**ON-SITE SEWAGE DISPOSAL SYSTEM
 HOWARD COUNTY HEALTH DEPARTMENT
 BUREAU OF ENVIRONMENTAL HEALTH**

SUBDIVISION: Brantwood 3/1 LOT NUMBER: 1

ADDRESS: 3033 Seneca Chief Trail PROPERTY OWNER: _____

Title: REVISION ⑤ TO GPO2-34 BRANTWOOD SECTION 3 AREA 1 LOT 1		
Date: 12/5/01	Drawn: LDE	
Scale: 1" = 50'	LDE Job No.: 01-043	Sheet: 1 OF 1

Approved Septic System Plan
 Howard County Health Department

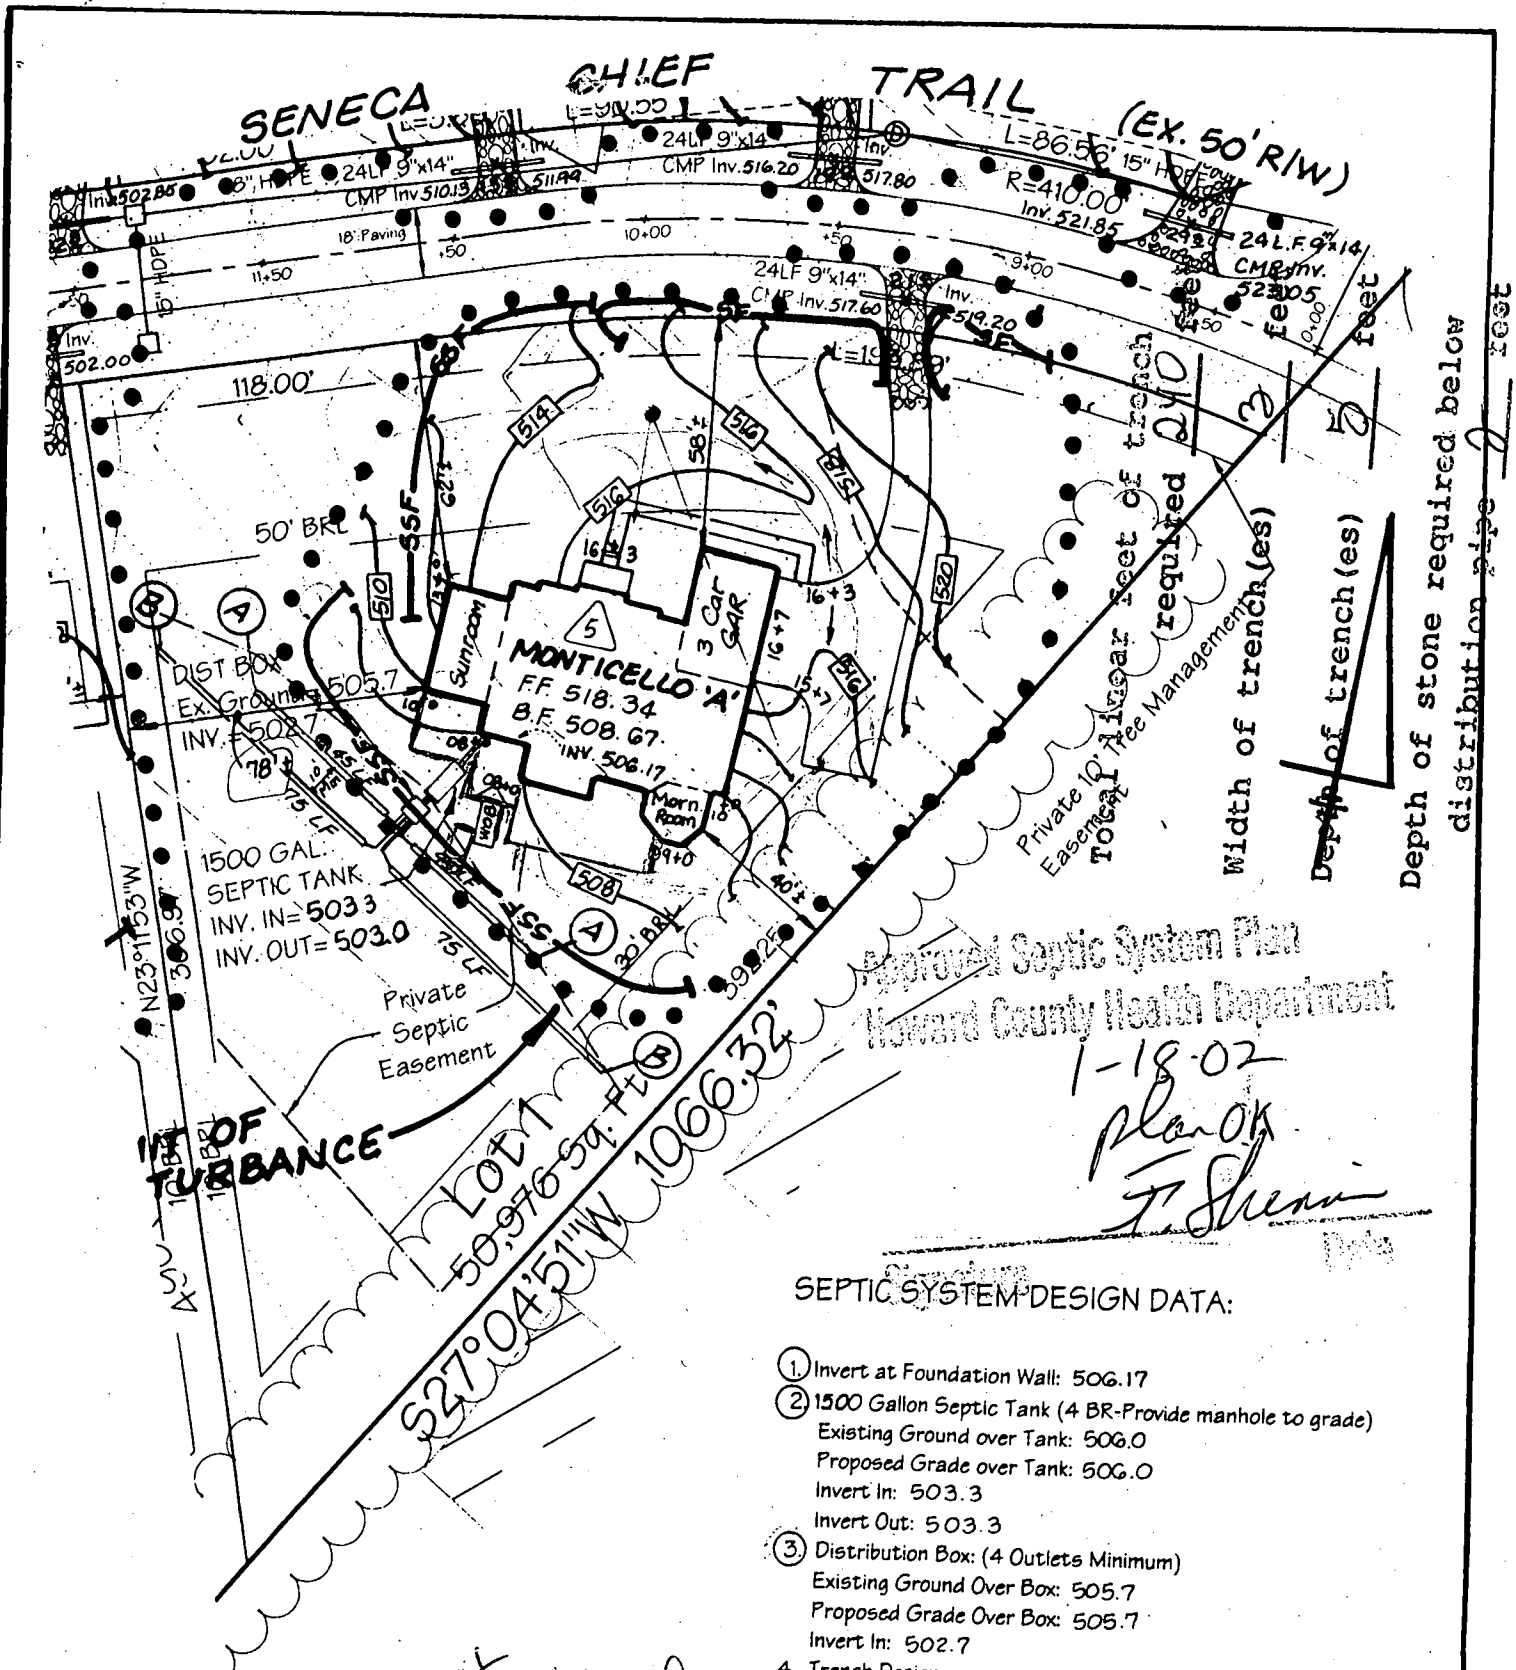
PRE-CONSTRUCTION INSPECTION: 4/15/02 Contour not as shown. Contr. needs to sheet contour. Top corner of SRA will probably be lost. Manse moved (SO)

INSPECTION COMMENTS: 4/16/02 Not Ready (SO) 4/18/02 Tank set as close to the house as possible, but is partly in reserve area, set DB as close as possible to S.T. 4/18/02 (2) 75' Trenches installed, OK to cover (SO) 4/23/02 (2) 45' trenches installed, OK to cover all work (SO)

LOCATION DRAWING

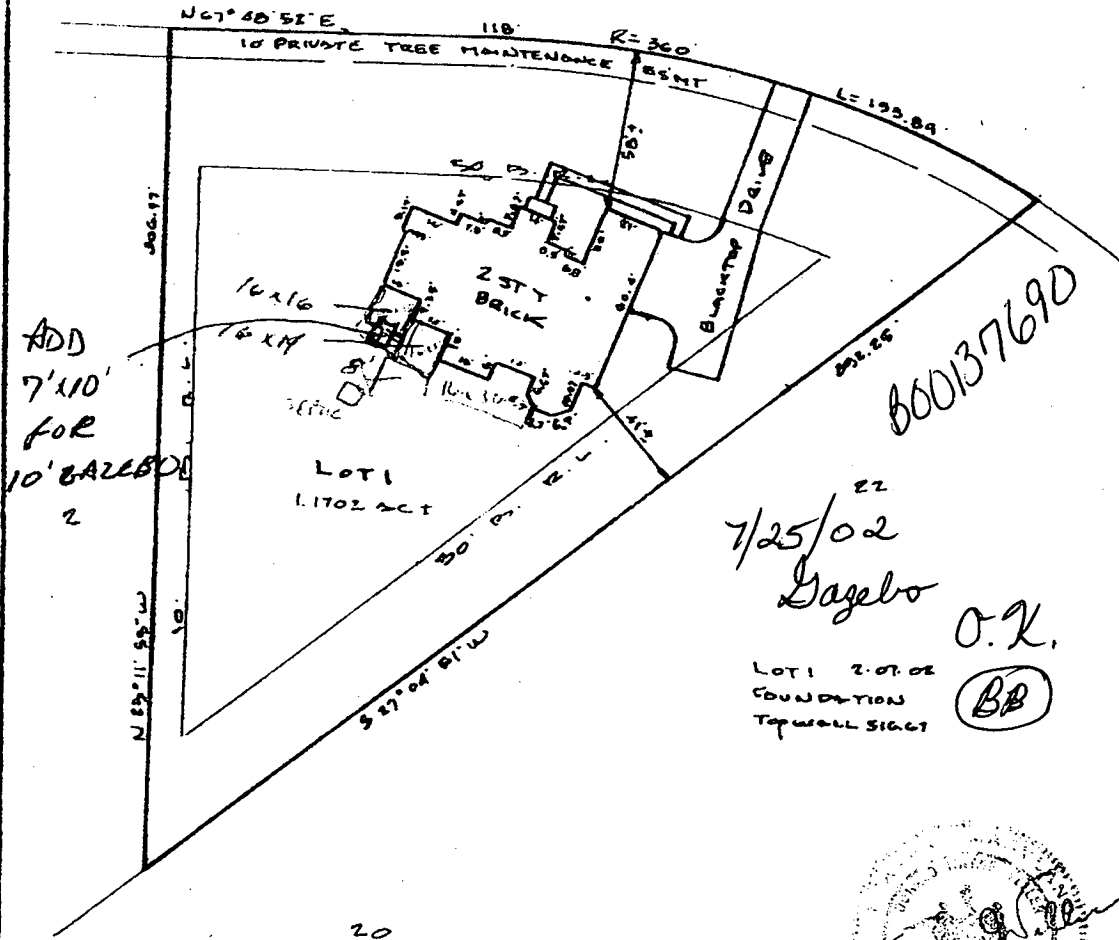
ADD
7' x 10'
FOR
10' GAZEBO
2

22
7/25/02
Gazbo

O.K.

LOCATION DRAWING

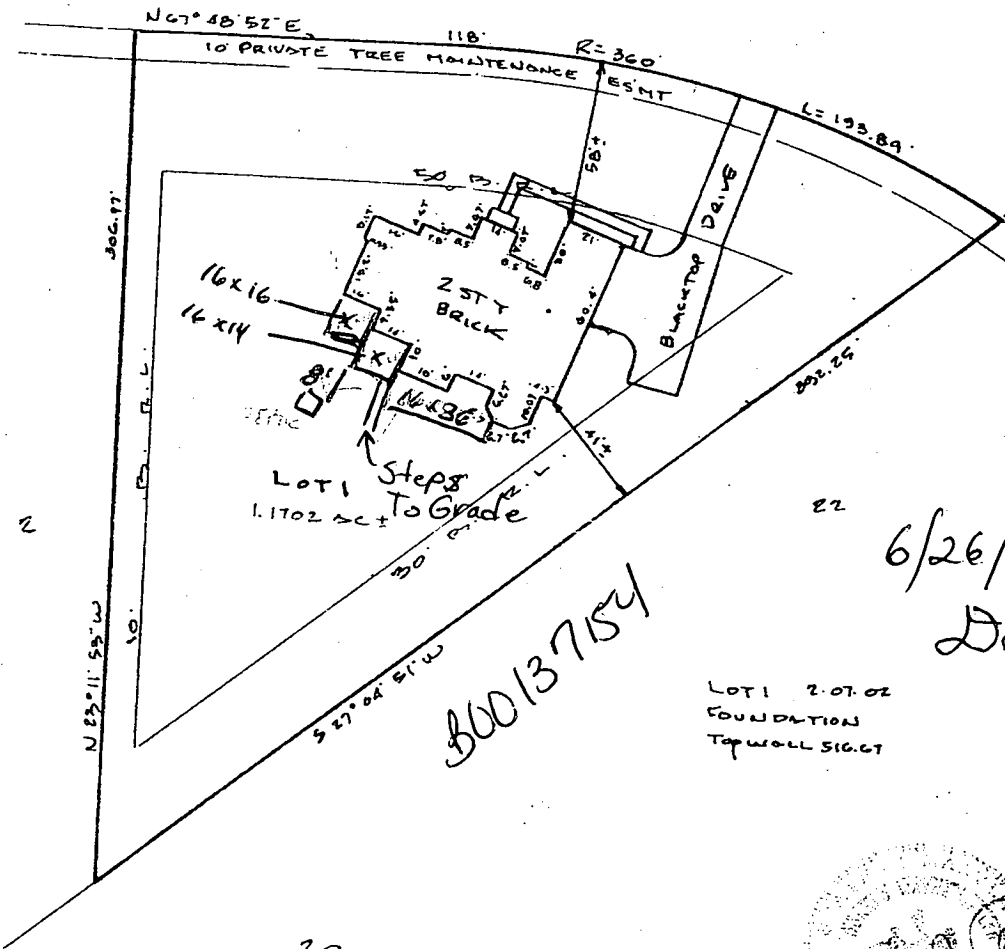
6/26/02 Proposed
Deck O.K.

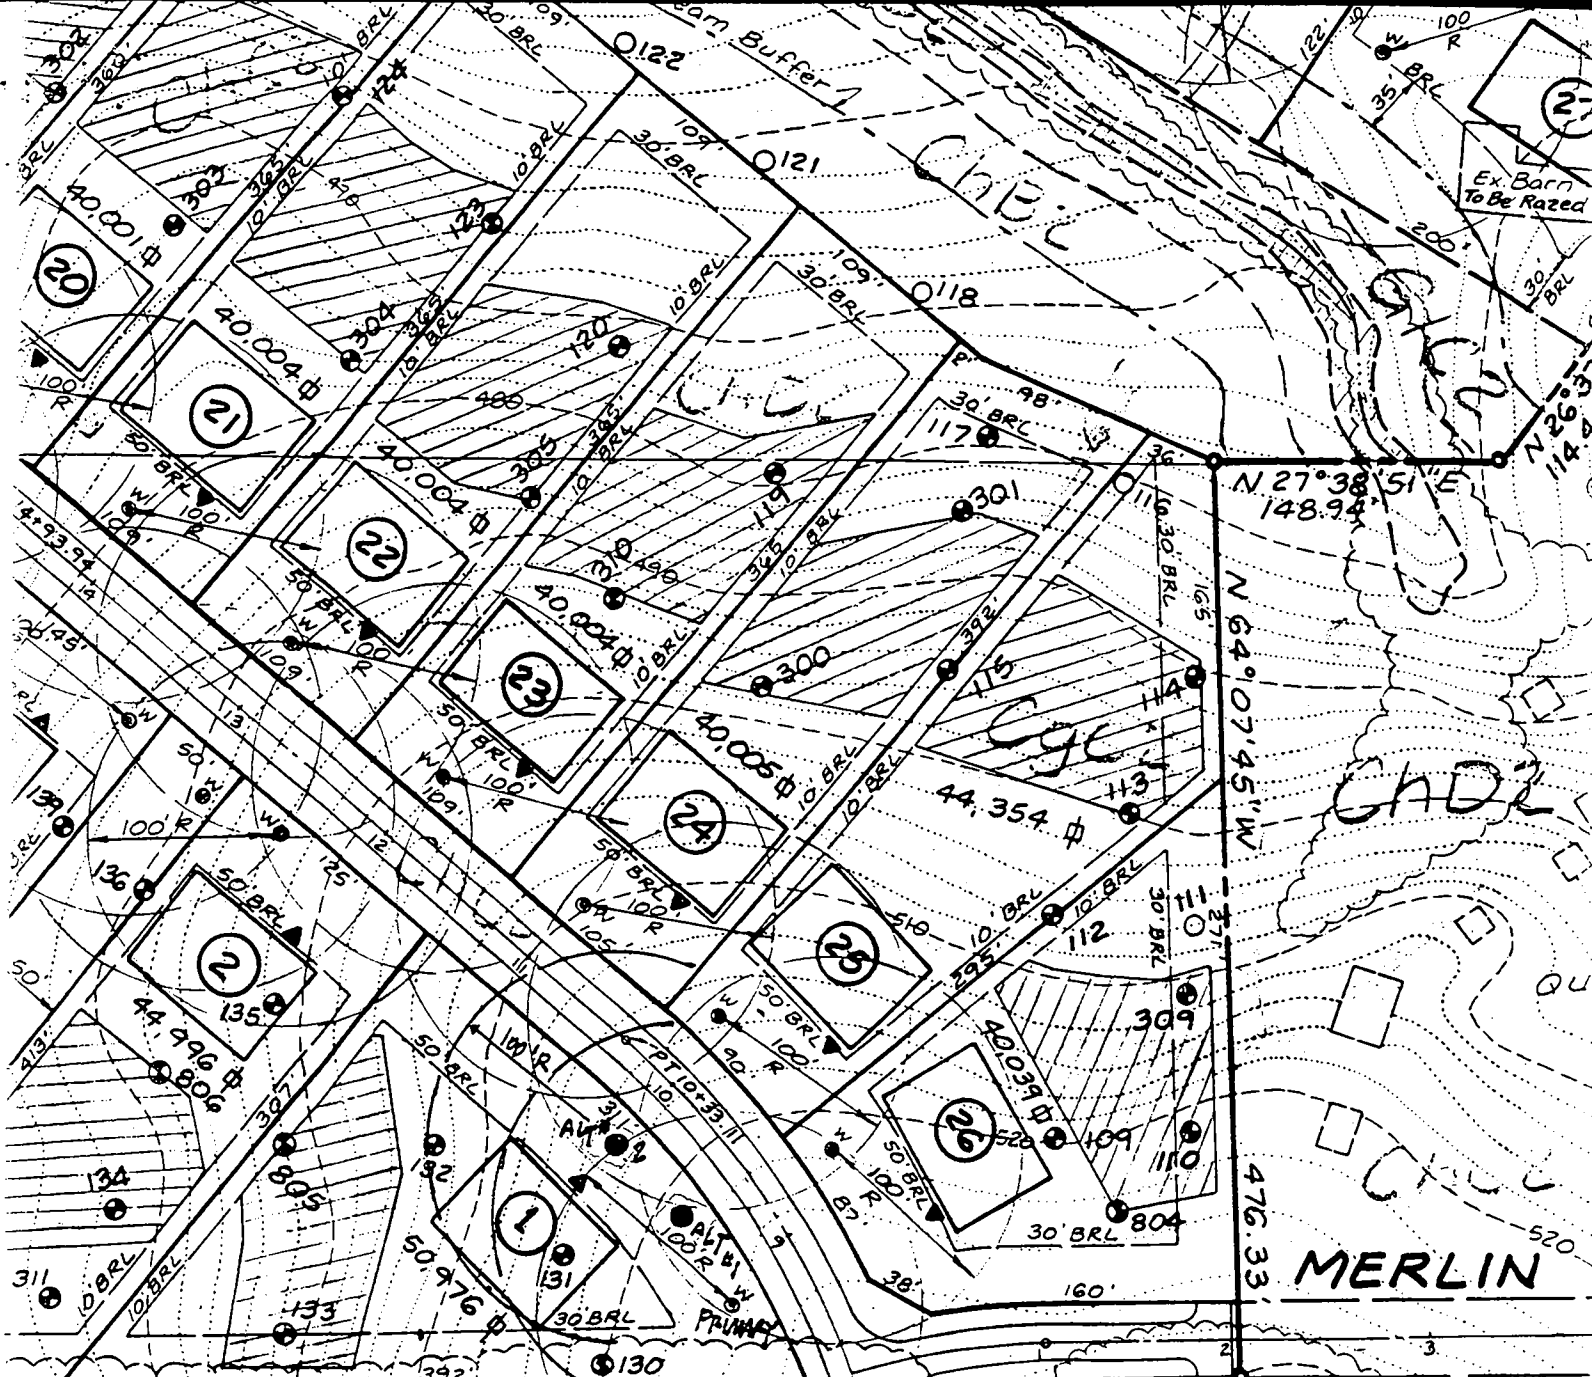
Shown alternate well sites are OK.
Brantwood 3/1 - Lot 1.
